# **A G E N D A**

## **Architectural Review Board**

**May 24, 2016**

753 Thorn Place

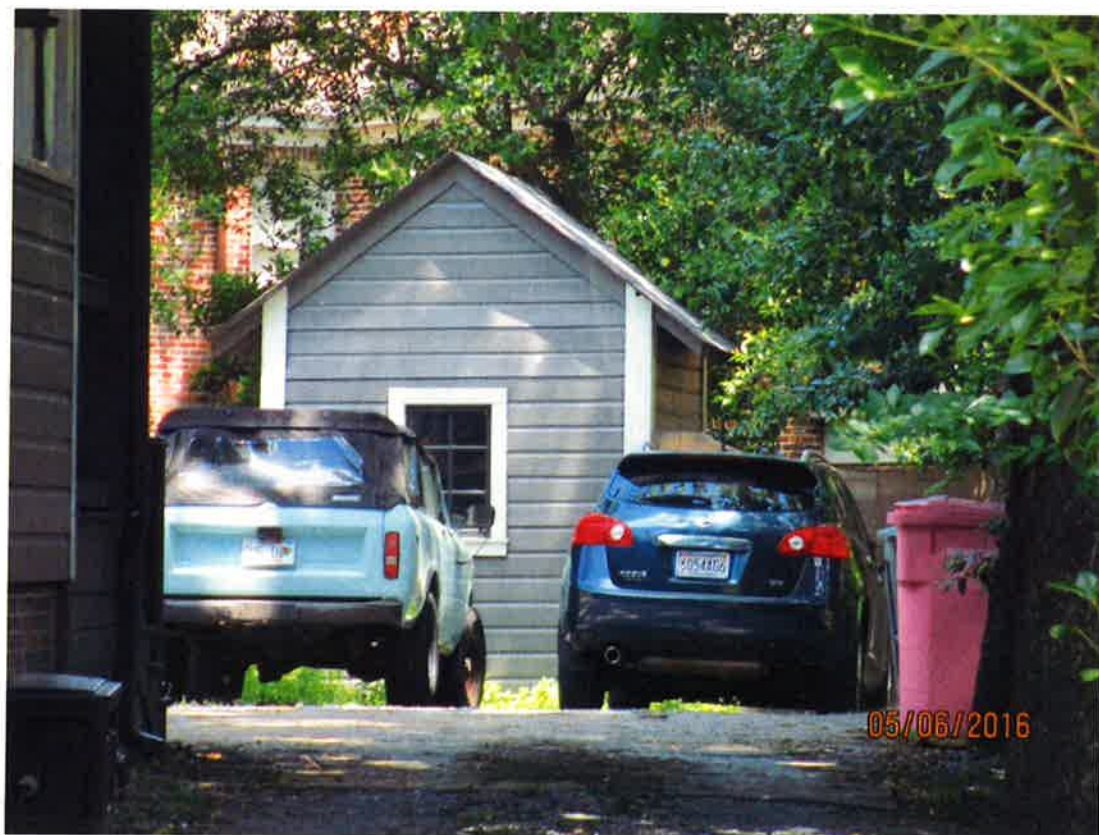
- On May 19 (prior to ARB), this project is going to the Board of Adjustment for a setback (approximately 1' from the side property line and 1' from the rear) and coverage variance.
